Report of Meeting L-60-1 Surveillance Panel PRI Headquarters, Apollo Room, Warrendale, Pa. June 21, 2006

Report of Meeting L-60-1 Task Force PRI Headquarters, Apollo Room, Warrendale, Pa. June 20, 2006

DRAWING NO A-6-6376-19-Z21203 Page L-60-1

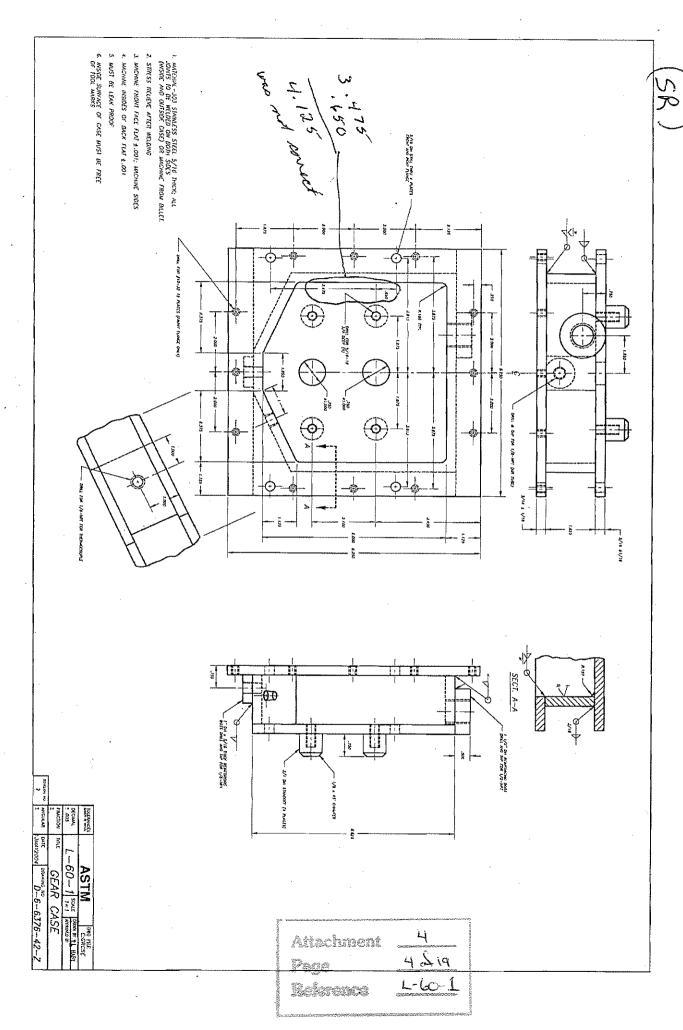
Drawing A-6-6376-19-Z – Seal Plate Bolts

Hector: Ask SwRI to place a note on the threaded end lengths as being typical as well as the nut width of 0.5".

SwRI/LZ: To make new studs.

Lower Shaft

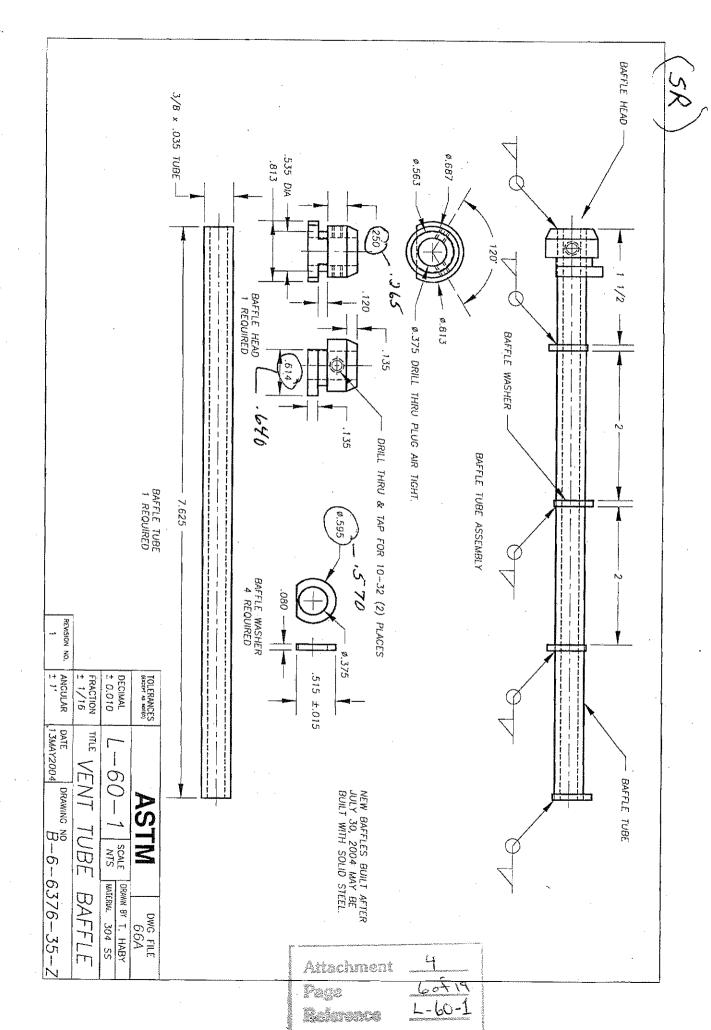
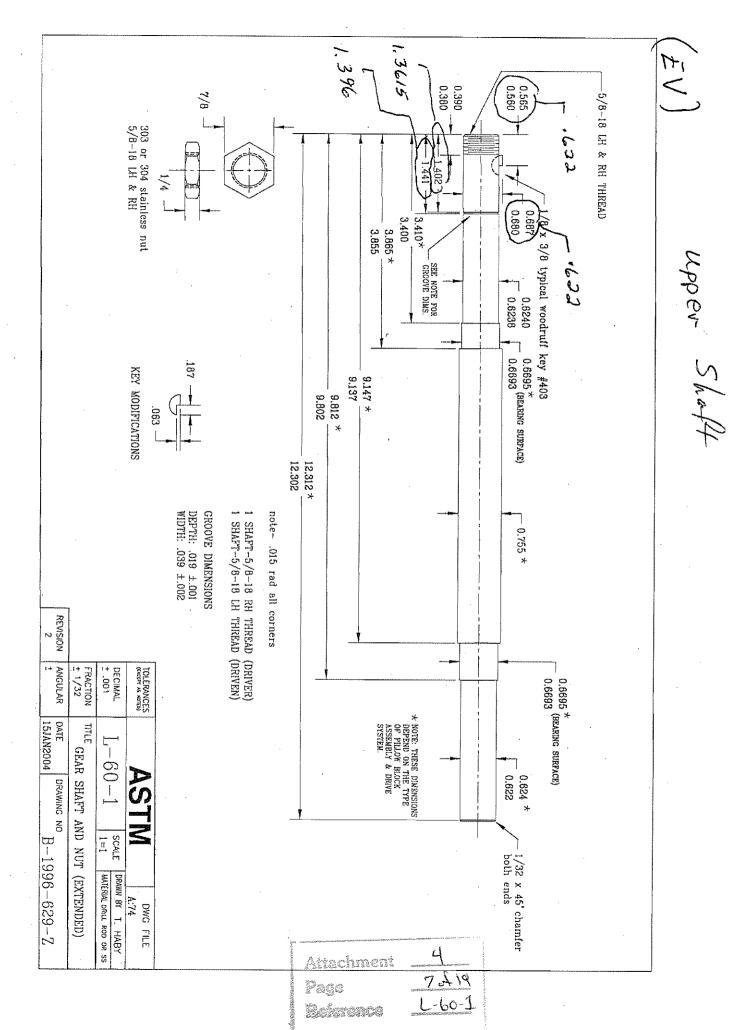
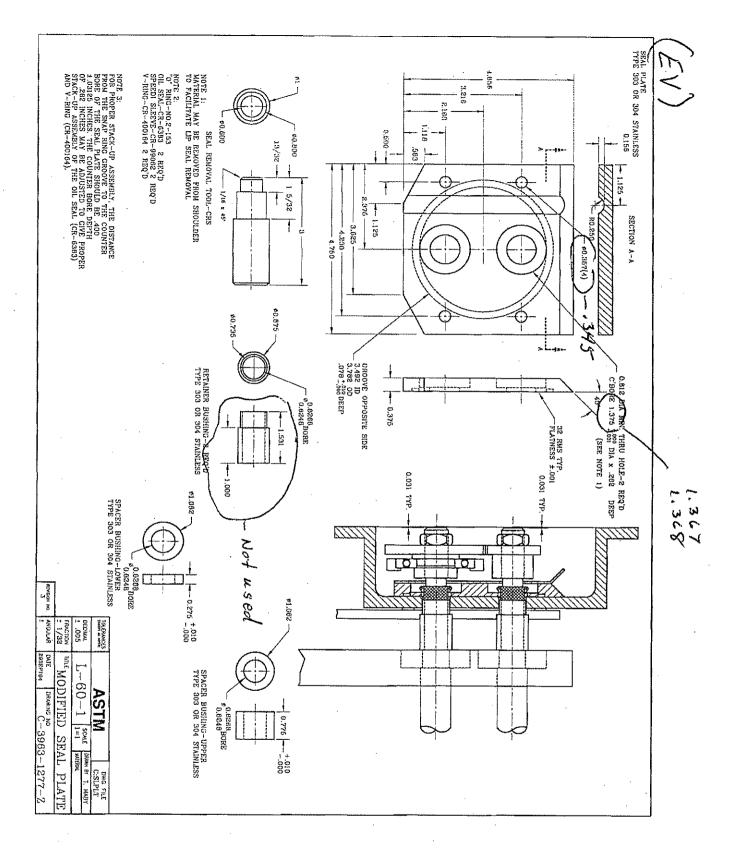
Task Force recommendations and action items: B-1996-629-Z

Drawing B-1996-629-Z pertains to the manufacturing dimensions for the gear shafts. We do not have empirical data to prove that these dimensions have an effect on severity. However the shaft dimensions are part of determining the location of the gears within the gear case. The Task Force agrees that the most critical performance criteria is the location of the gears within the gear case. This relates to static lube coverage of the lower gear, lube splash during rotation, and heat transfer. However a tool is needed for confirming the stack-up dimensions meet the performance specification which we currently to do not have for the location of the gear. The group recognizes that forecasting the outcomes from multiple stack-up tolerances on the gear location is hard to determine. The Task Force recommends that the labs be allowed to continue with their current driveshaft configuration until a tool is built to determine the absolute gear location in the case.

Place a note stating the drawing tolerances are for manufacturing only.

Place an asterisk next to the 'Key Modification' stating typical.
